Re: P230318-02
Roof - Osage Lot 5 A1-A4 Repair

Pages or sheets covered by this seal: I61909933 thru I61909936

Job	Truss	Truss Type	Qty	Ply	Roof - Osage Lot 5 A1-A4 Repair	I61909933
P230318-02	A1	Roof Special Structural Gable	1	1	Job Reference (optional)

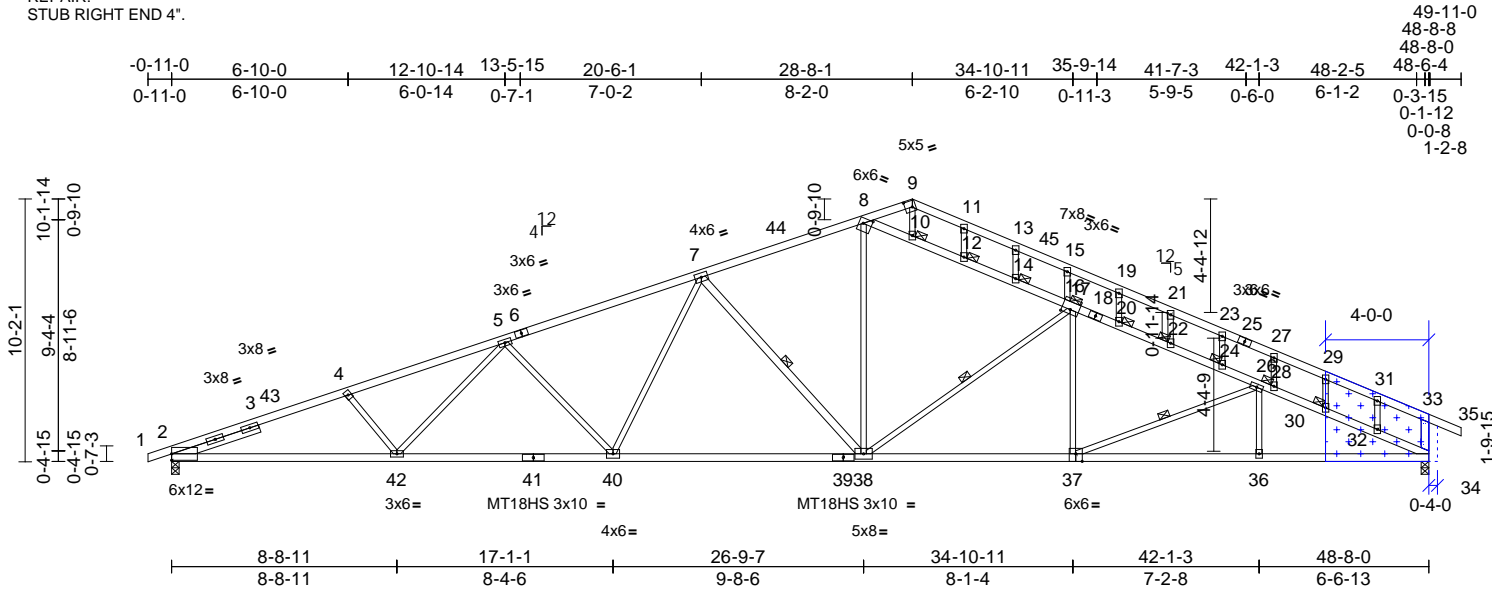
REPAIR:
STUB RIGHT END 4".

ATTACH < 2 LAYERS > 3/4" PLYWOOD OR OSB GUSSET (23/32" RATED SHEATHING 48/24 EXP 1)
TO ONE FACE OF TRUSS WITH (0.131" X 3.0") NAILS PER THE FOLLOWING NAIL SCHEDULE:
2 X 3'S - 2 ROWS, 2 X 4'S - 3 ROWS, 2 X 6'S AND LARGER - 4 ROWS: SPACED @ 2' O.C.
USE 2" MEMBER END DISTANCE. GLUE PLYWOOD LAYERS TOGETHER PRIOR TO ATTACHING TO TRUSS.

INSTALL 2 X 4 SPF/DF/SP NO.2
CUT TO FIT TIGHT.

Job P230318-02	Truss A2	Truss Type Roof Special	Qty 2	Ply 1	Roof - Osage Lot 5 A1-A4 Repair Job Reference (optional)	I61909934
-------------------	-------------	----------------------------	----------	----------	---	-----------

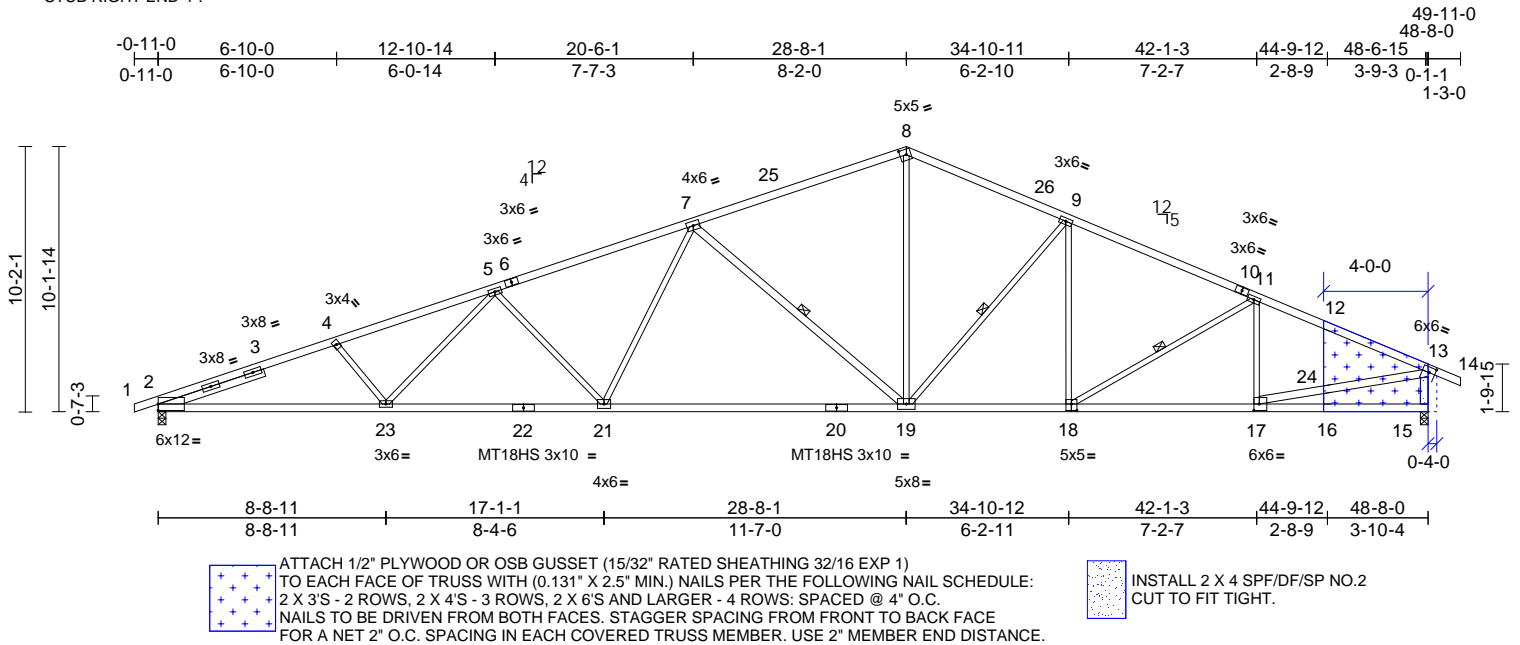
REPAIR:
STUB RIGHT END 4".

Job P230318-02	Truss A3	Truss Type Roof Special	Qty 5	Ply 1	Roof - Osage Lot 5 A1-A4 Repair Job Reference (optional)	I61909935
-------------------	-------------	----------------------------	----------	----------	---	-----------

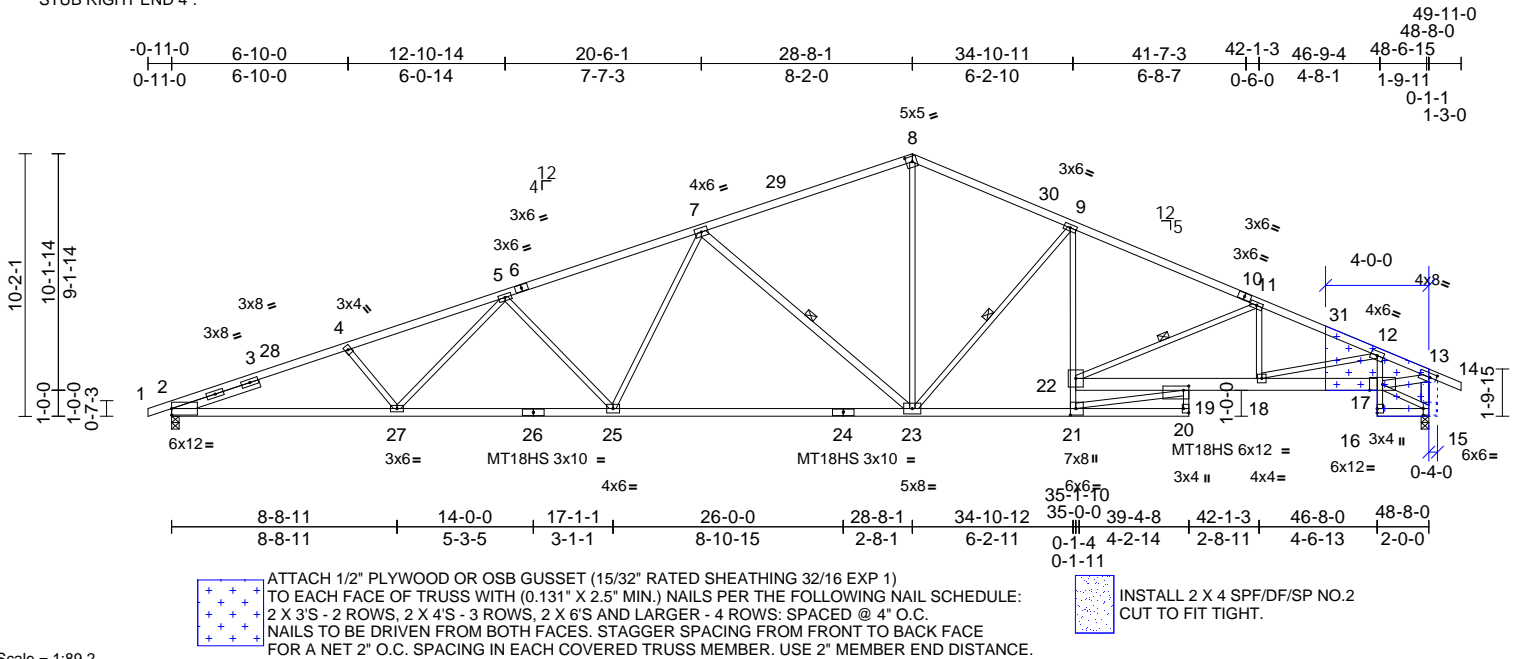
REPAIR:
STUB RIGHT END 4".
